STATE OF WASHINGTON
DEPARTMENT OF HEALTH
 SOUTHWEST DRINKING WATER REGIONAL OPERATIONS
 P.O. Box 47823 Olympia, Washington 98504-7823
 TDD Relay 1-800-833-6388

April 12, 2016 Dell Hilger 1121 Westside Highway Kelso, Washington 98626	Beacon Hill Water and Sewer District ID #15650D	
	County:	Cowlitz
	System Type:	Group A Community
	Operating Permit Color:	Green
	Surveyor:	Teresa Walker
	Inspection Date:	March 30, 2016

Ostrander reservoir hatches

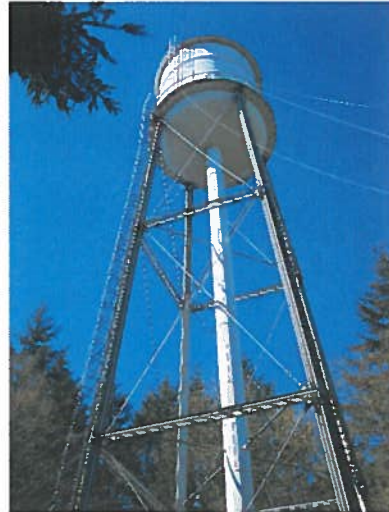
Ostrander does not have a gasketed hatch, as it is a manhole cover to an at-grade reservoir. **Please provide a watertight seal for this cover.** Ostrander and Skyline are below grade reservoirs and have at grade vents which are screened. Beacon Hill is an elevated steel tank supported by a steel truss. Beacon Hill will have a structural inspection performed next month. The vent for Beacon Hill does not have a screen. **Please modify the vent opening and install screens for Beacon Hill reservoir. Please confirm that the Beacon Hill tank support structure is structurally sound, following the inspection.**

1. **Please provide a watertight seal for the Ostrander reservoir cover.**
2. **Please modify the vent opening and install screens for the Beacon Hill reservoir.**
